STAFF RECOMMENDATION
1418 Franklin Avenue
April 20, 2016

Application: New construction-detached accessory dwelling unit (DADU)
District: Eastwood Neighborhood Conservation Zoning Overlay
Council District: 06
Map and Parcel Number: 08305036300
Applicant: Steve Johnson
Project Lead: Paul Hoffman, paul.hoffman@nashville.gov

SITE PLAN 1

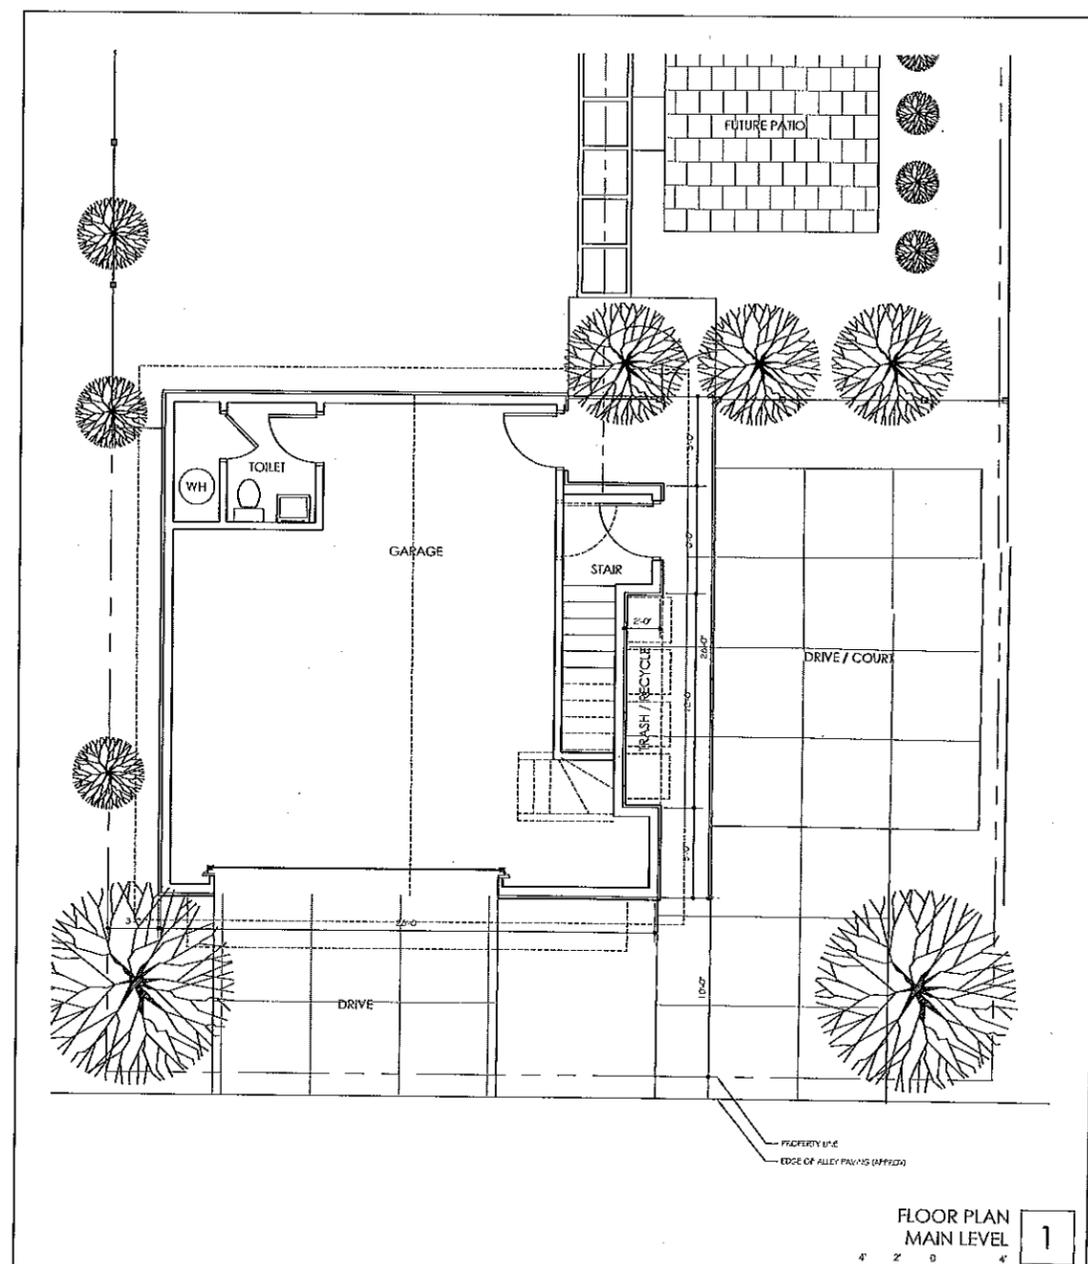
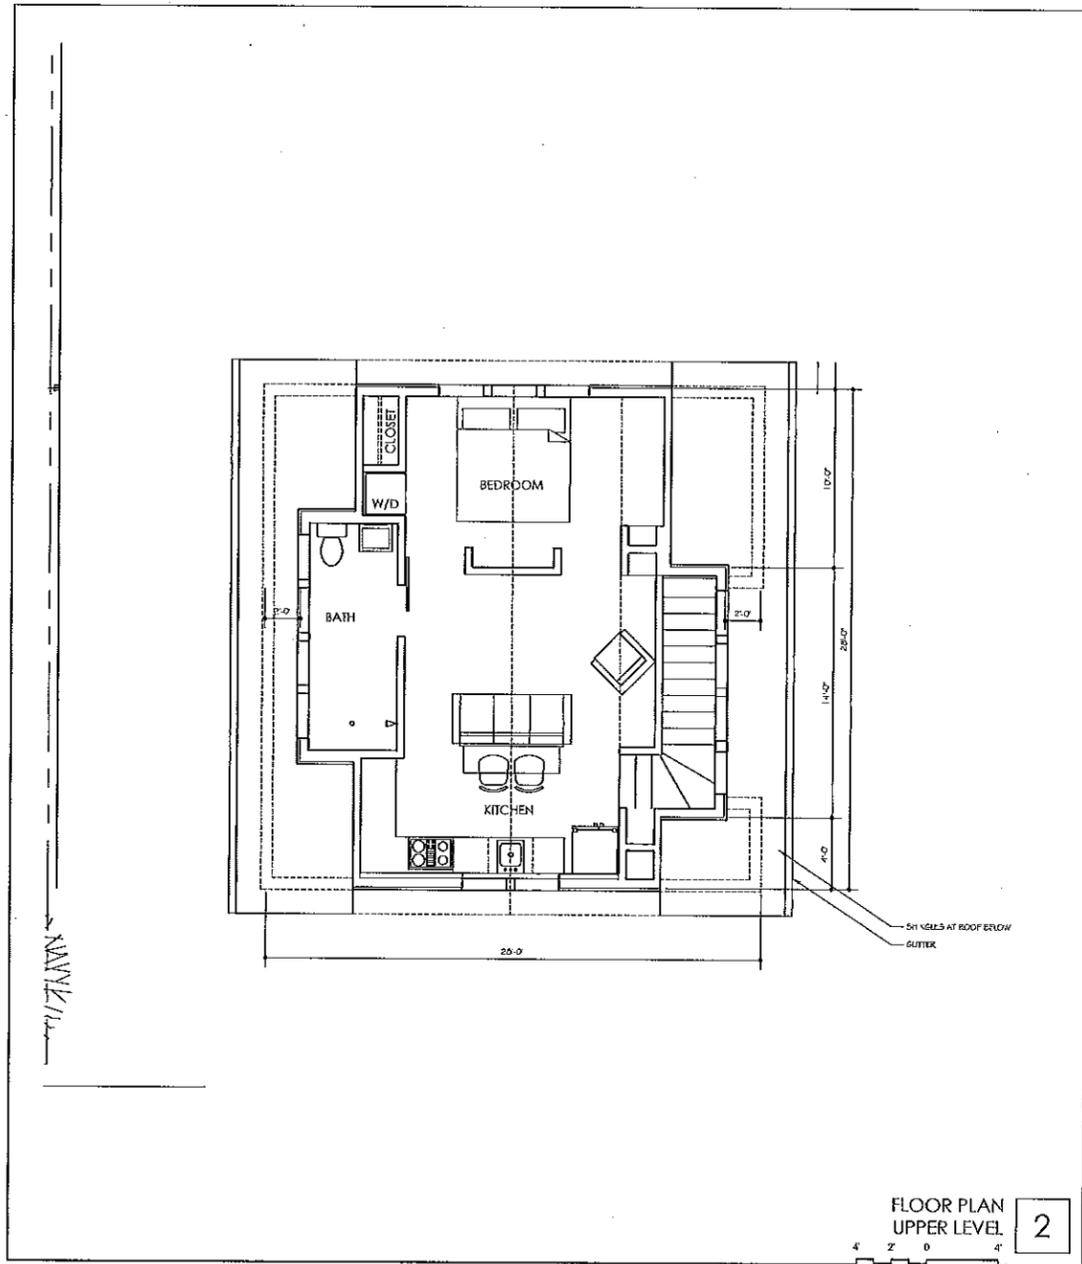
Location, Setbacks: The location is at the rear of the lot, accessed from the alley. The rear setback will be ten feet (10'), which meets bulk standards.

DADU: There is an existing garden shed with a footprint of approximately three hundred and twenty square feet (320 sq. ft.). Per the Code, no outbuilding may exceed two hundred square feet (200 sq. ft.) when there is a DADU on the lot. The applicant has agreed to remove the existing outbuilding, or rebuild it to the required square footage. A restrictive covenant is required and has not been received; staff includes this as a condition of approval.

1. Staff approve the windows, doors and garage doors;
2. Staff approve the roofing color;
3. The existing garden shed on the lot be removed; and
4. The applicant file a restrictive covenant.

ELEVATIONS

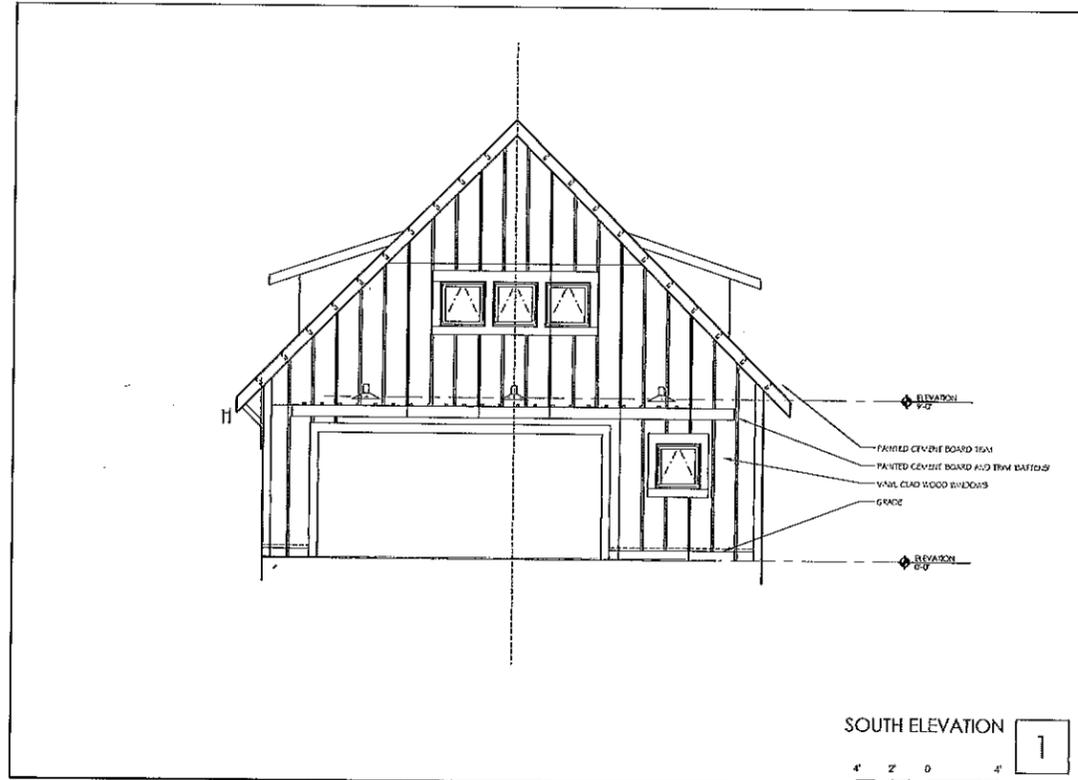
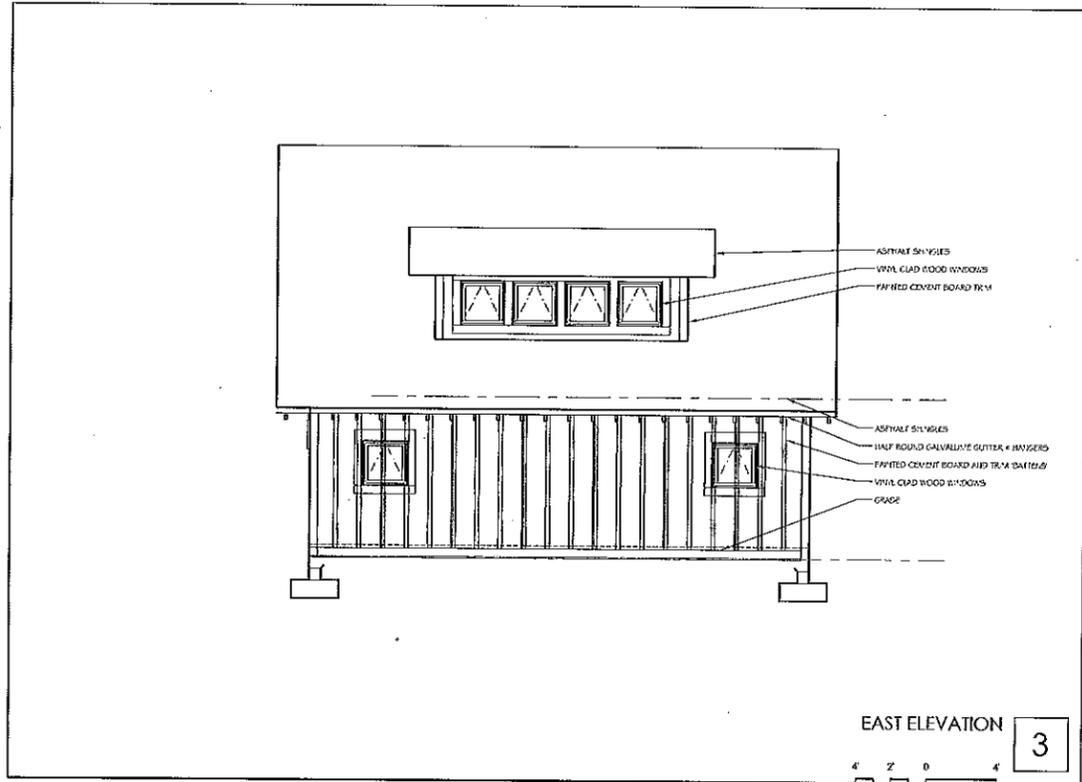
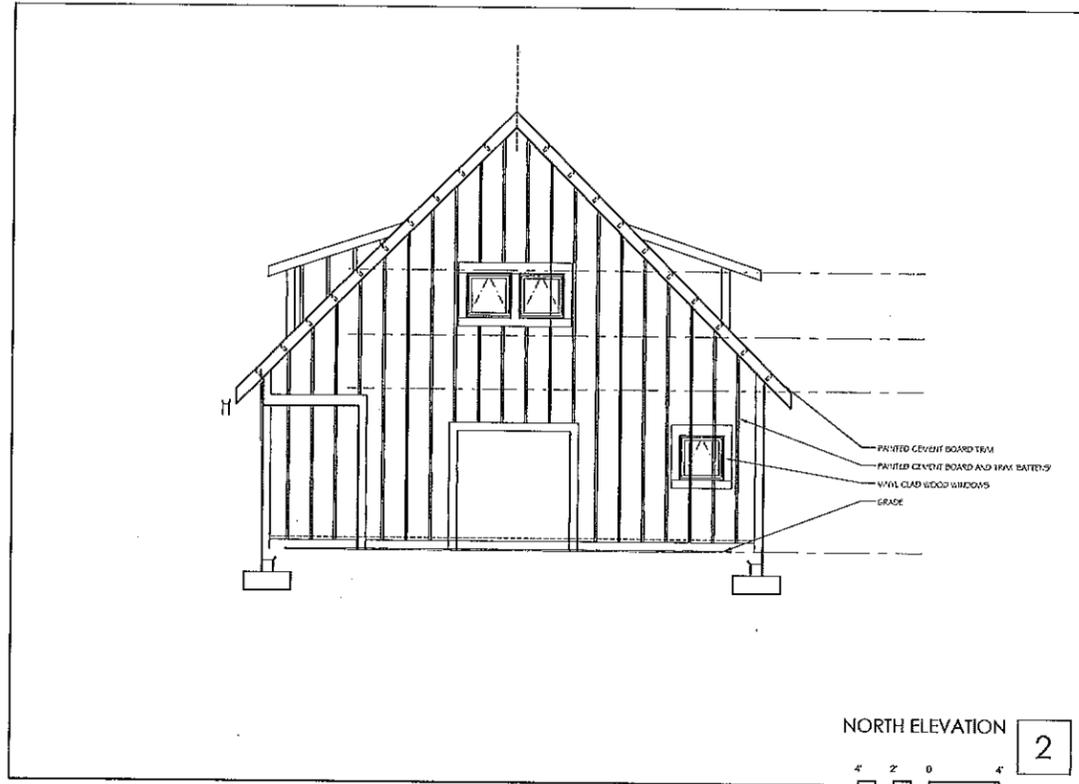
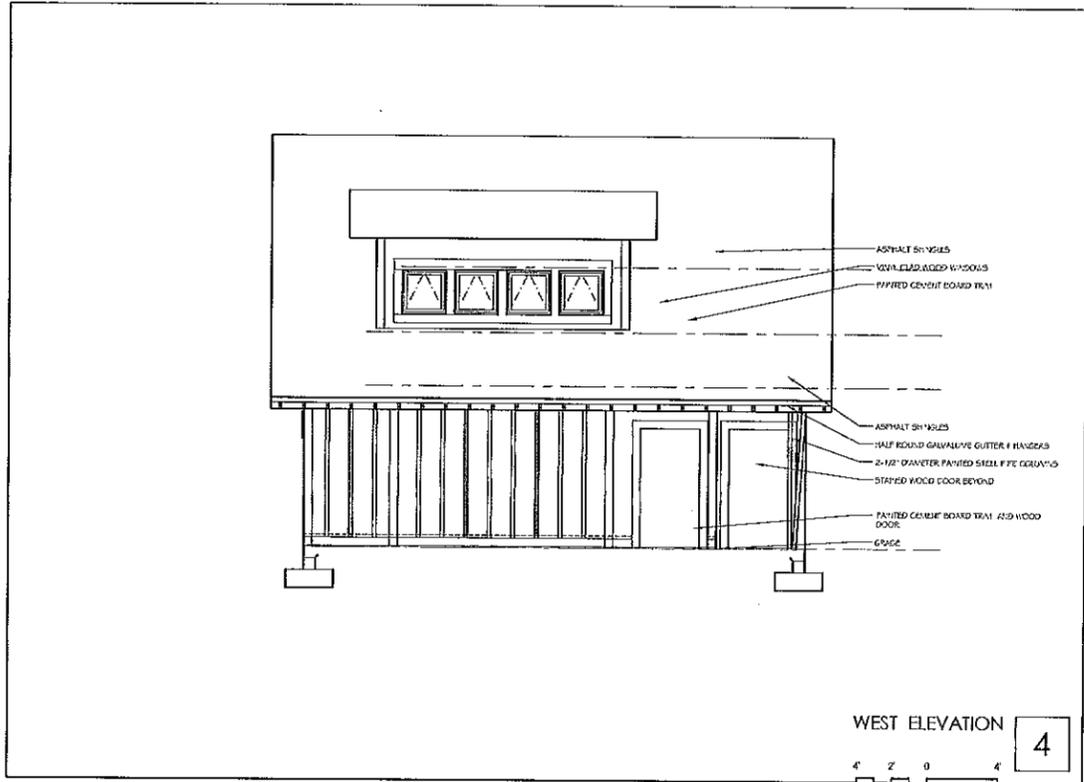
Height/Scale: The proposed outbuilding is one-and-a-half stories and has a footprint of six hundred and seventy-six (676 sq. ft.) The ridge height is proposed at twenty-three feet (23'), with an eave height of eight feet (8'). The ridge height of the house is twenty-three feet (23'). The eave height and ridge height are no greater than the corresponding heights on the house, and are appropriate.

Materials: The materials include fiber-cement board-and-batten siding, fiber-cement trim, asphalt shingles, wood doors and vinyl-clad wood windows. Staff requests final review of windows, doors and garage doors, and roofing color as a condition of approval.
